In the Office Action claims 1-3, 5, and 7 were rejected under 35 U.S.C. 103(a) as being unpatentable over Bonnema, et al. (U.S. Patent No. 4,726,490) in view of Kristoffersson (U.S. Patent No. 5,685,452), and claims 4 a were rejected under 35 U.S.C. 103(a) as unpatentable over Bonnema, et al. in view of Kristoffersson and Thomas (U.S. Patent No. 5,791,098). This rejection is traversed for the following reasons. Bonnema, et al. disclose a circular hollow lid with flat upper and lower sides and an elongated channel 41 which extends from one edge to the center of the lid. Kristoffersson discloses a container bottom member 1 having parallel elevations or ridges 5 on the top side which form parallel recesses which extend to opposite edges of the bottom member. In Figs. 1-8 the bottom member has upper parallel ridges 5 which cross lower parallel ridges 5. In Figs. 9-11, the bottom member 1 has only one level of parallel ridges 5. In the embodiments of Figs. 1-11, the parallel ridges 5 of the bottom member 1 which define the upper surface of the bottom member 1 all define parallel recesses which extend to the outer edges of the bottom member. In Figs. 3-11, it appears that the upper side

FIGURE 9

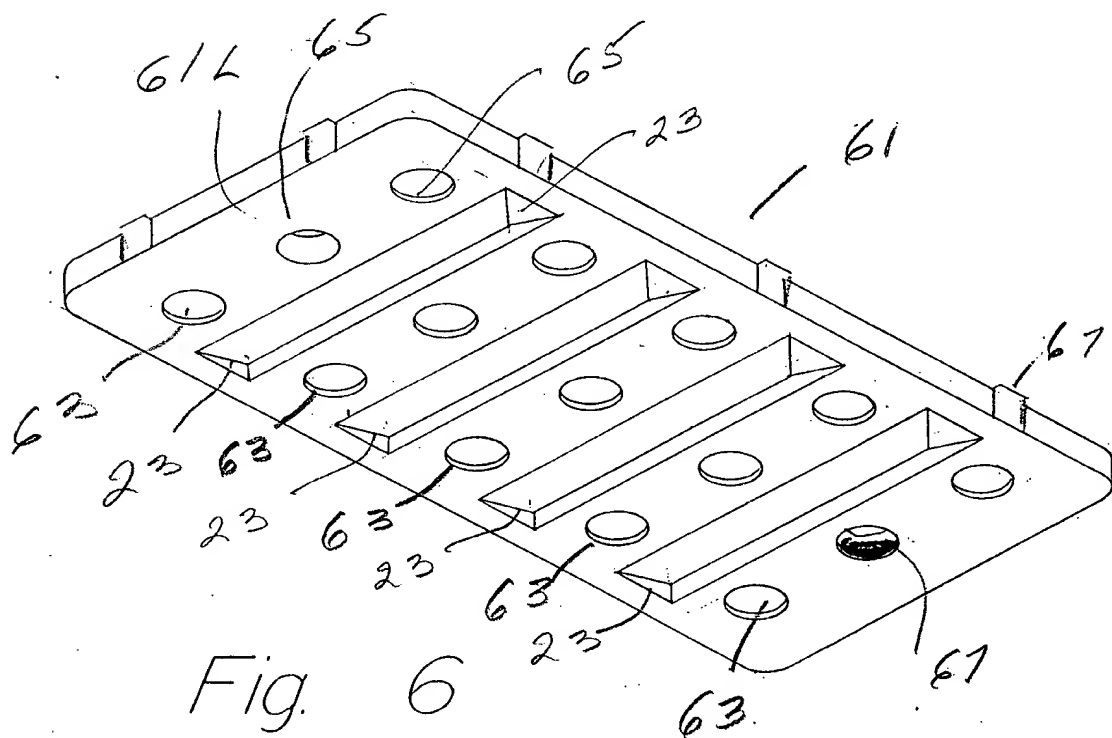
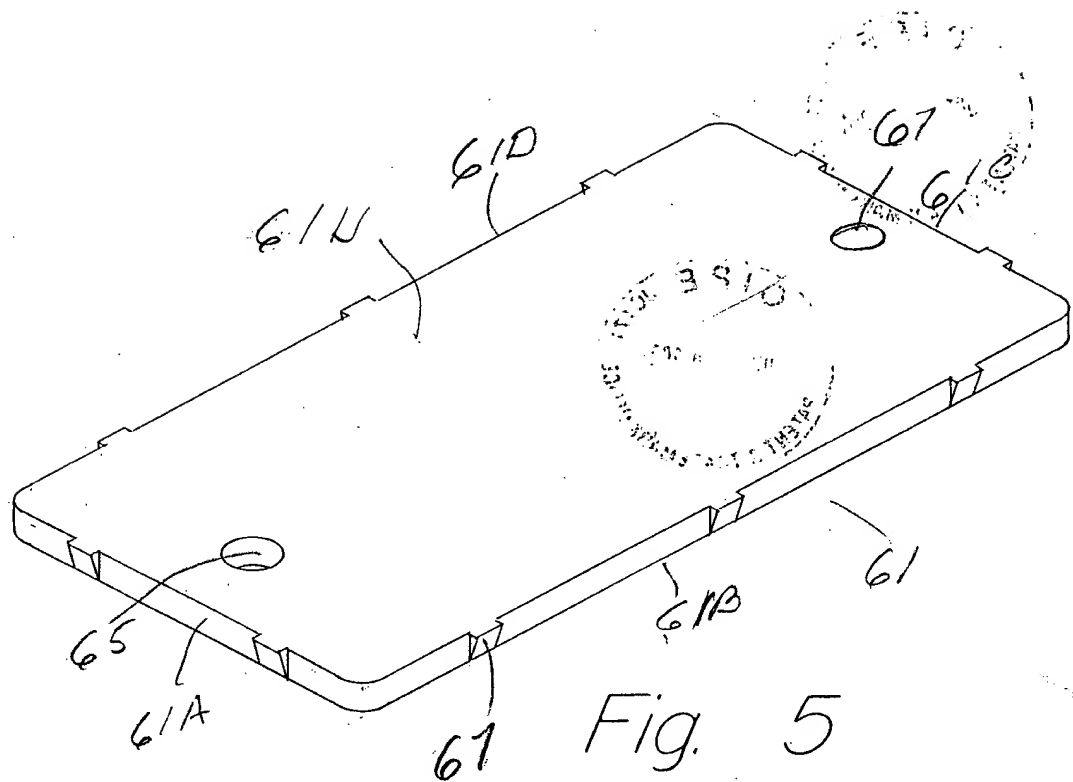
Permission is requested to amend Figs. 2 and 10 as shown in red in the enclosed drawings thereof in conformance with the first four lines of page 2 of the specification and with Figs. 9 and 10 of the drawings. Note that the first four lines of page 2 of the specification refers to Figs. 9 and 10 and obviously Figs. 9 and 10 are cross-sections of Figs. 2.

FIGURE 10

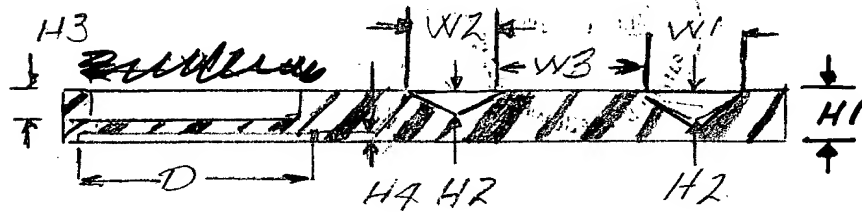
In lines 34-36 of page 2 of the specification, reference is made to W2 which is indicated to have a dimension of 2½ inches. W1 is indicated to have a dimension of 2 inches. Thus, the W2 on the left of Fig. 10 should be removed since there is no reference in lines 34-36 of page 2 to this W2.

Also page 2, lines 34 and 35 refer to H1 as having a height of 1 ½ inches. This is the height of the member of Fig. 10 which is consistent with the other dimensions of the member of Fig. 10 and with line 33 of page 3 of the specification. Hence the addition of H1 to Fig. 3 is appropriate and not new matter.

The deepening of the two slots in Fig. 10 also is consistent with Figs. 2 and 9.
